PRODUCT ADVISORY

3M™ DBI-SALA® Delta™, ExoFit™, ExoFit™ Plus & ExoFit™ XP Cross Over Style Harnesses ANSI & OSHA Versions

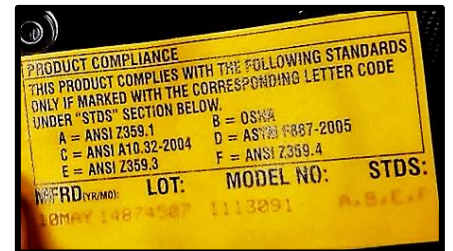
End Users: If this notice of non-compliance to the ANSI requirement is of concern to you, please inspect your Cross Over Style Harness label(s) (see photograph to right) to determine if it is one of the affected part numbers and was manufactured before May 1, 2021. Once you have confirmed the part number & affected date, please contact 3M Customer Service at 1-833-638-2697 or at 3musfpserviceaction@mmm.com and provide us with contact information. We will have someone contact you to discuss the following remediation options:

1. Remediate your product(s) at your location.
 - 3M will ship D-ring sleeve(s) and instructions for application of the D-ring sleeve(s) directly to you at 3M's expense.
2. Return affected product(s) to 3M for remediation by 3M.
 - A UPS shipping label will be created for you to facilitate the return of your affected product(s).
 - Returned product must pass a pre-use inspection. If it passes the inspection, 3M will apply the D-ring sleeve(s) to your harness(es) and return the remediated product to you at 3M's expense. If it fails inspection, we will dispose of the product and contact you.
